CITY PLANNING COMMISSION
1231 "I" STREET, SUITE 200, SACRAMENTO, CA 95814

- A. Negative Declaration
- B. Special Permit to develop three single family residences containing 1,567± square feet each on three parcels totaling 0.34± vacant acres in the General Commercial (C-2) zone.

LOCATION: 5611, 5621 and 5631 Wilkinson Street

Subject: P-90-377

EXHIBIT - A SITE PLAN

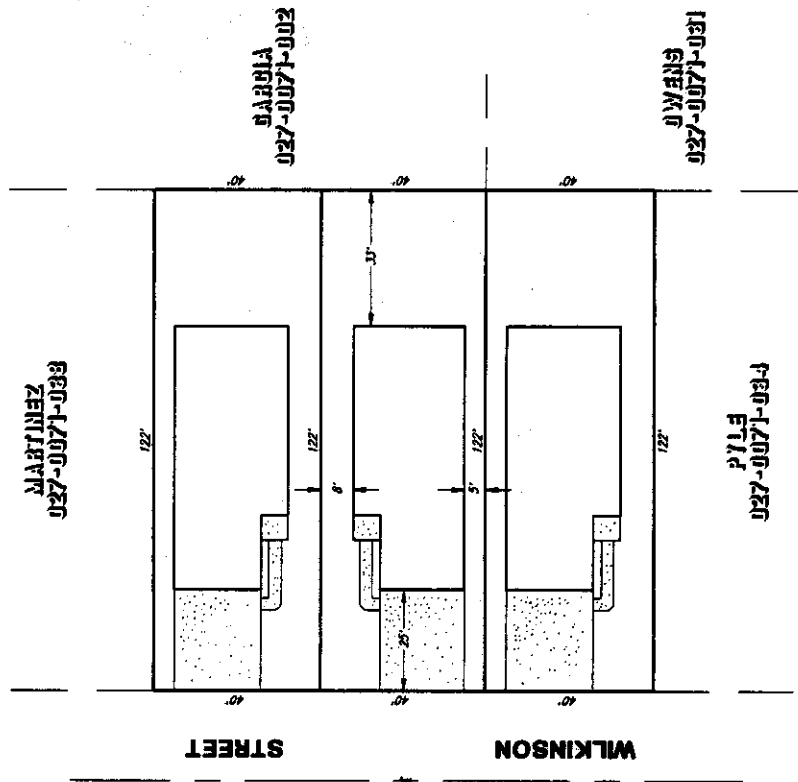
The three units will be the same floor plans with similar elevations. The units will have a 25 foot front setback with a 33 foot rear yard setback. The side setbacks will be five feet on one side and eight feet on the other side. The site plan shows the garages and driveways ten feet apart for the middle lot and south lot (Exhibit A). Staff suggest flipping the middle plan so that the two garages and driveways are not together.

The subject site is adjacent to a convenience market. The north property line is adjacent to the parking area of the market. When staff visited the site the were several people gathered in the parking area. The Zoning Ordinance requires that a six foot high masonry wall be constructed when a commercial use is constructed adjacent to a residential use or zone. However, the market is existing and would not have been required to construct a wall since it is adjacent to a vacant commercial site. Since the applicant is proposing to construct residential units on the commercial site, staff recommends a six foot high masonry wall, finished on both sides, along the north property line separating the commercial use from the residential use. The Environmental Services Division has required a seven foot wall as a sound attenuation measure. Staff further recommends wood fencing be constructed on the property lines (side and rear) of each unit subject to the requirements of the Fence Ordinance in order to provide a private yard area for the residences of each unit and to delineate lot lines.

1. A seven foot high masonry wall, finished on both sides, shall be constructed along the north property line subject to the requirements of the environmental mitigation measure.

2. A six foot high wood fence shall be constructed along the side and rear property lines of the three lots in accordance with the Fence Ordinance.
3. The front yard of each lot shall be irrigated and landscaped with grass and a tree.

EXHIBIT - B ELEVATIONS

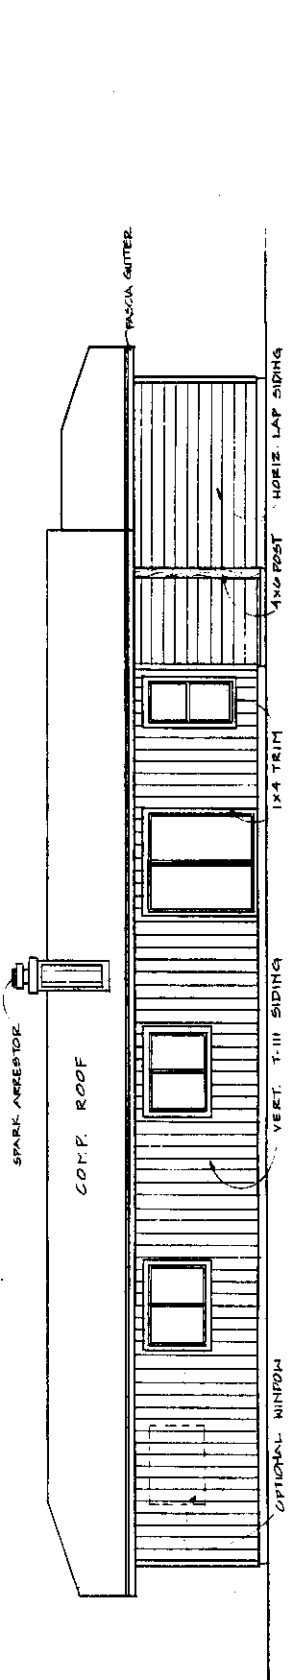
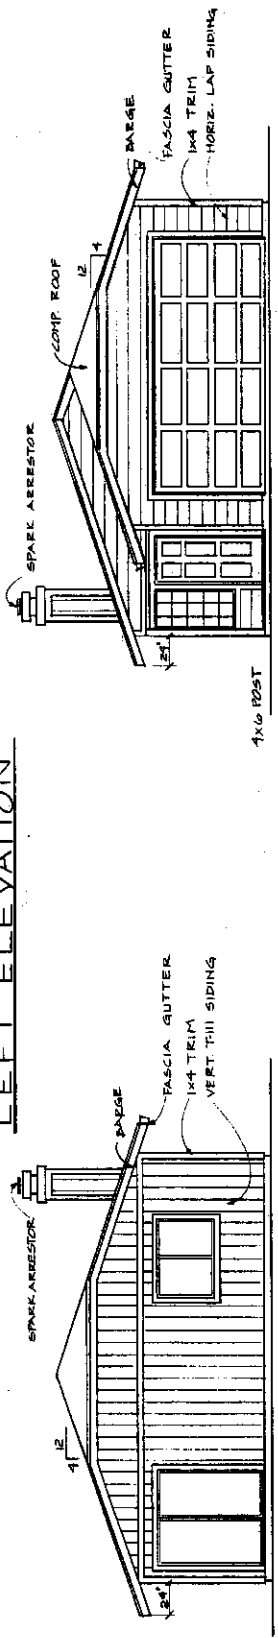
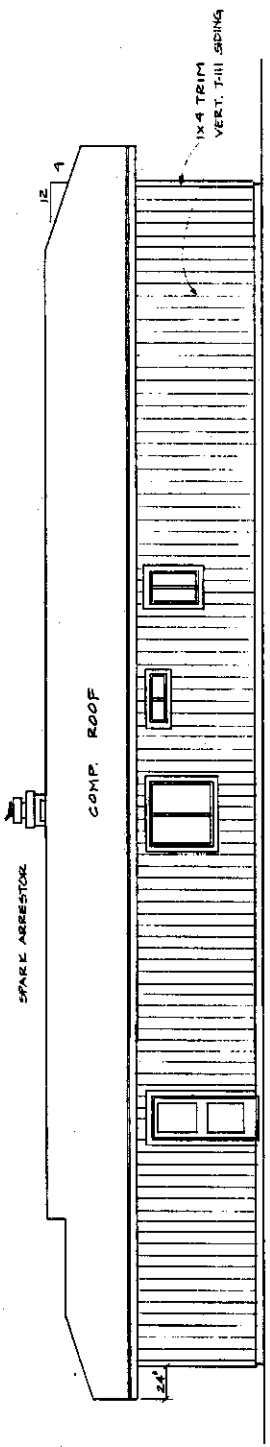
Staff had some concerns regarding the submitted elevations. Staff met with the applicant regarding these concerns. The applicant has agreed to the following recommendations (Exhibit F). Staff recommended the horizontal lap siding be wrapped around the side of the units a minimum two feet. The horizontal lap siding should carry through on the three sides (north, south and west) of the chimneys. The siding on the three units should be varied utilizing six inch and eight inch siding, such as six inch siding on the end units and eight inch siding on the middle unit. The window on the left elevation should match the grid type utilized on the front elevation.

Staff further recommended the roofing material to be a 25 year laminated dimensional shingle in a color to compliment the colors used on each unit and the front yards of each lot be landscaped and irrigated. The applicant did not agree to these changes maintaining the upgrade in the roofing material and the addition of landscaping and irrigation in the front yards will add additional cost to the project, thus eliminating affordable housing (Exhibit F). It is standard practice to require a 25 year laminated dimensional shingle and front yard landscaping and irrigation on projects reviewed by the Design Review staff in areas such as Oak Park and Del Paso Heights. It is also standard practice to review the elevations and make recommendations when an entitlement

4. A 25 year laminated dimension shingle in a color to compliment the unit color shall be installed.
5. The lap siding shall be wrapped around the side of the units a minimum of two feet.

6. A grid window shall be installed on the side elevation to match the proposed grid window located in front.
7. The applicant shall use the horizontal lap siding on the three sides (north, south and west) of the chimneys.

8. A variation of siding shall be used on the units, six inch siding on the end units and eight inch siding on the middle unit.
9. Mechanical equipment shall not be visible from the front of the units.

ELEVATION "B"

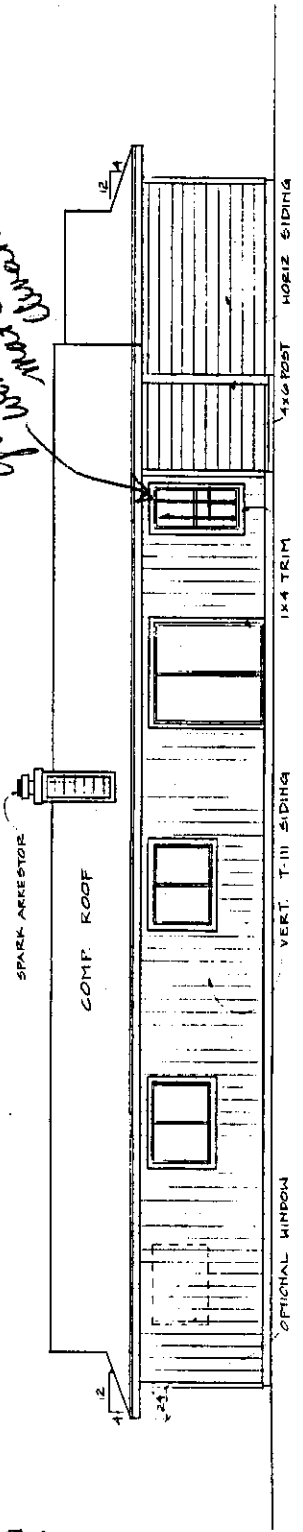
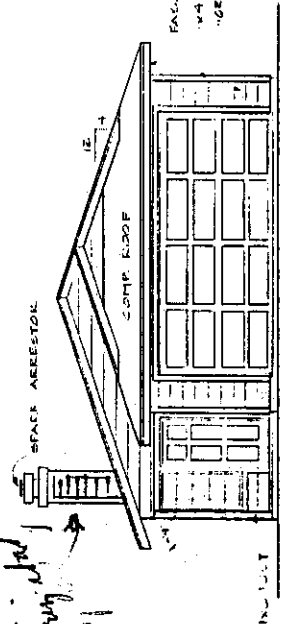
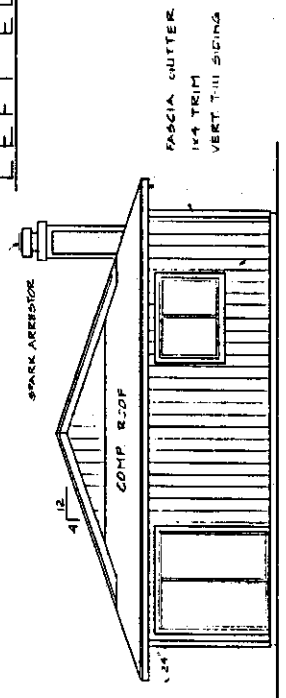
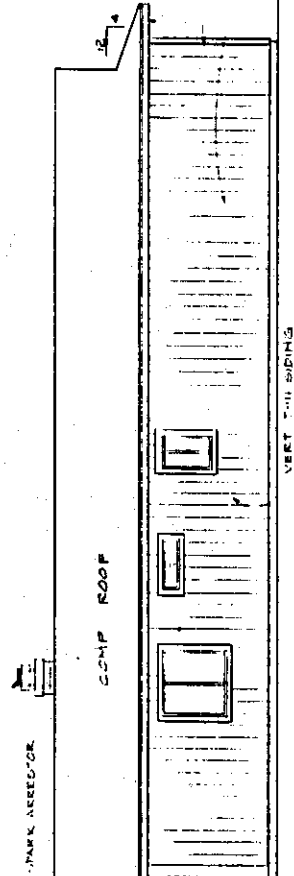
Handwritten note:
Spark arrester
Material price
to be

Handwritten note:
Spark arrester
to be

Handwritten note:
Spark arrester
to be
